Proposal for the 03 series of amendments to Regulation No. 58 (Rear underrun protection)

The text reproduced below was prepared by the expert from Germany based on the documents ECE/TRANS/WP.29/GRSG/2015/17 and the provisions given in documents ECE/TRANS/WP.29/GRSG-108-13 from CLCCR, ECE/TRANS/WP.29/GRSG-108-27 and GRSG-108-28 from OICA on rear underrun protection devices on heavy goods vehicles. The provisions in the document from CLCCR and OICA have been taken into account in this document as far as Germany can support the proposed amendments. In addition the wording gross vehicle weight was replaced by maximum mass throughout the entire text, as this wording is defined in section 2 of Regulation no. 58.

Figure 1

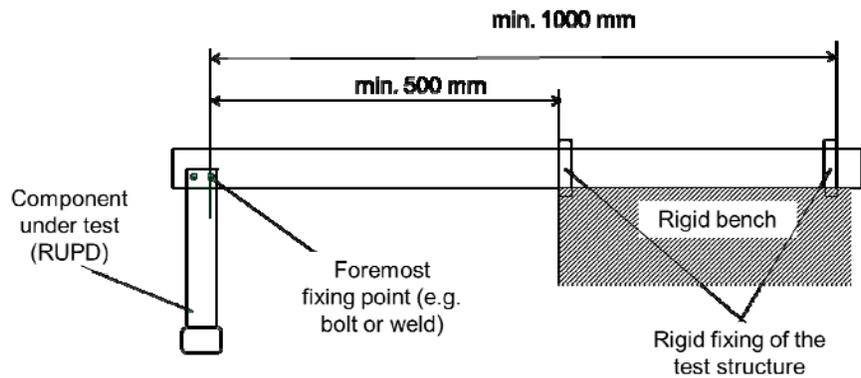
Paragraph 1.2., amend to read (including a new Figure 1):

"1.2. In the case of paragraphs 1.1.2., ~~and 1.1.3~~ the parts of the vehicle chassis ~~or to the rigid test bench~~ shall be on the vehicle. **The part of the chassis can be fixed on a test bench as shown in Figure 1, representing the minimum requirements to be fulfilled. The structures used as side rails shall be representative of the chassis of vehicles for which the underrun protection system is intended.**

The distance of the foremost fixing point of the RUPD from the rigid test bench shall not be less than 500 mm. If a diagonal strut is used to support the RUPD, this distance shall be measured between the foremost fixing point of the strut to the side rail structures and the rigid test bench.
